Atty Docket No.: JCLA11476-R

Serial No.: 10/695,018

REMARKS**Present Status of the Application**

Annotated Marked-up drawing**FIG. 1A (PRIOR ART)****FIG. 1B (PRIOR ART)**

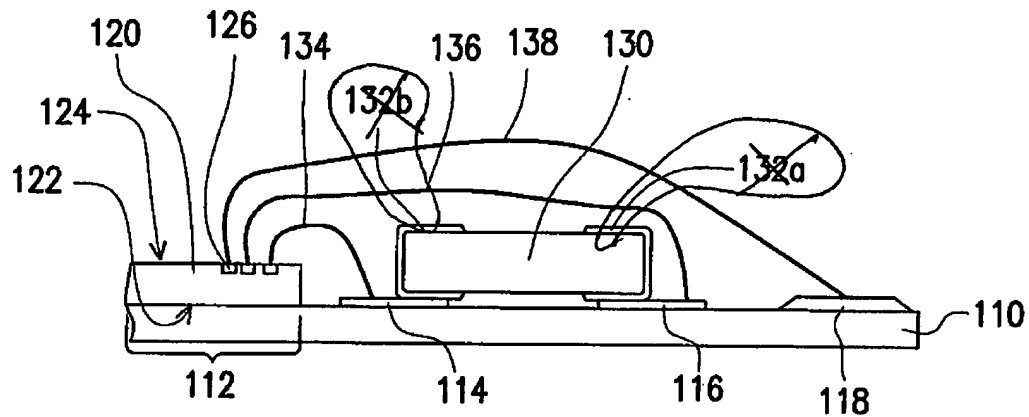
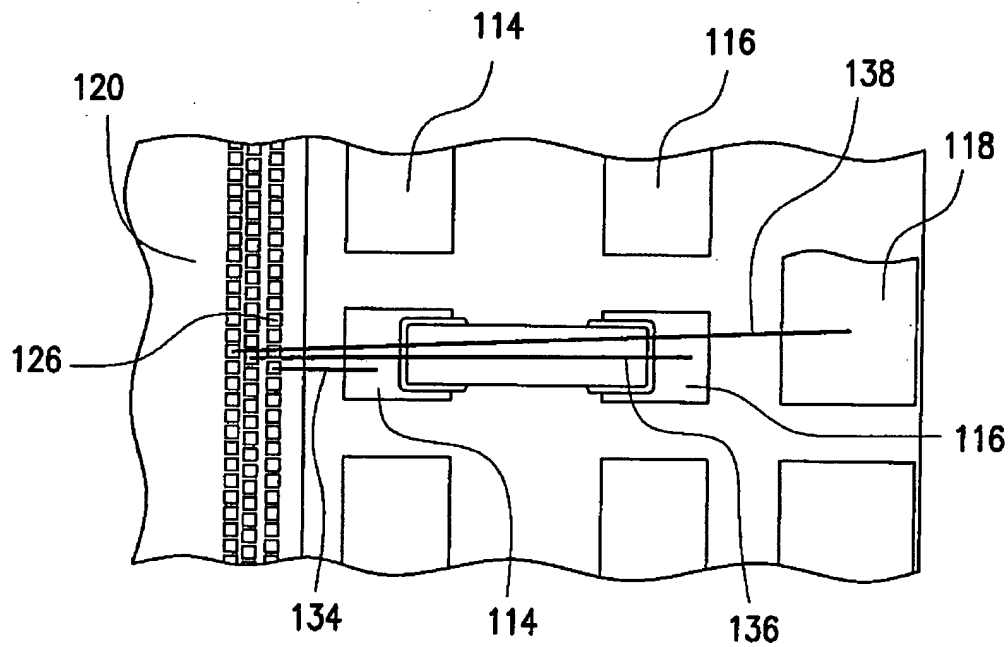
Figures 1B and 2B are objected to as failing to comply with 37 CFR 1.83(a) because they show inconsistent dispositional relationships between the passive component and the electrodes 132b and 232b and it is not clear whether the electrodes are at the top end of the passive element or at the sides thereof.

In response thereto, Applicants have amended Figures 1A, 1B, 2A, and 2B to clarify the dispositional relationships between the passive component and the electrodes 132b and 232b and to clarify that the electrodes are at the top end and bottom end of the passive element. Withdrawal of the objection is respectfully requested.
